LOT 390		
LOT No.	LOT WIDTH (M) (@ 5.8m)	LOT AREA (M <sup>2</sup> )
390	17.541	411.17

**Greenpark**  
project name  
RUSSELL GARDENS PHASE 4  
municipality  
HAMILTON  
date  
JUL 2021  
checked by  
scale  
1:250  
drawing no.  
20027-RG4-SITE-LAYOUTS  
GREG - H:\ARCHIVE\WORKING\2020\20027 GREY SITE PLAN\20027-RG4-SITE-LAYOUTS.dwg - Fri Aug 27, 2021 - 8:45 AM

lot/block no.  
390  
registered plan no.  
62M-1266  
project no.  
20027  
drawing no.  
1

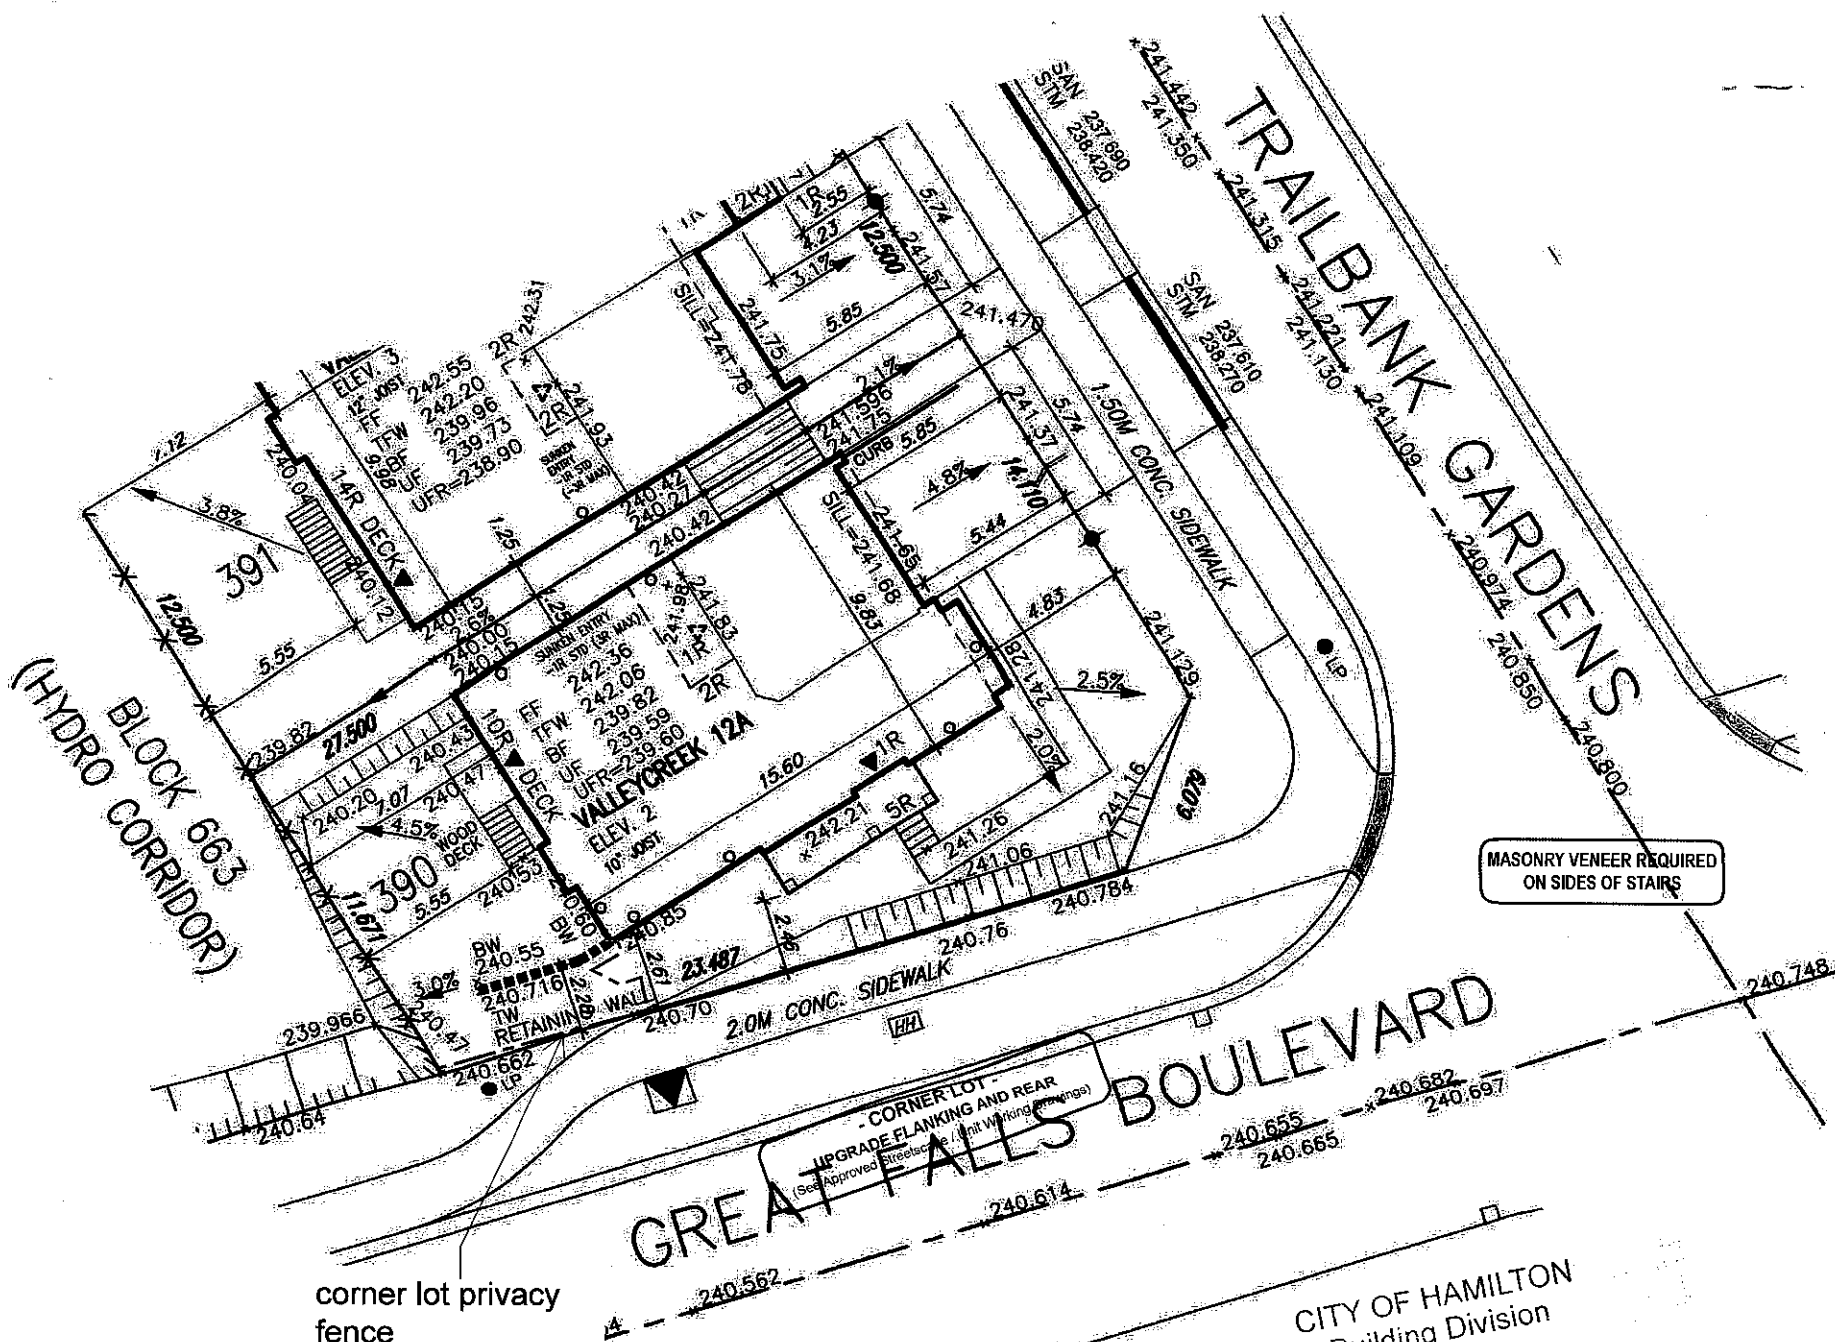
MASONRY VENEER REQUIRED  
ON SIDES OF STAIRS

corner lot privacy  
fence
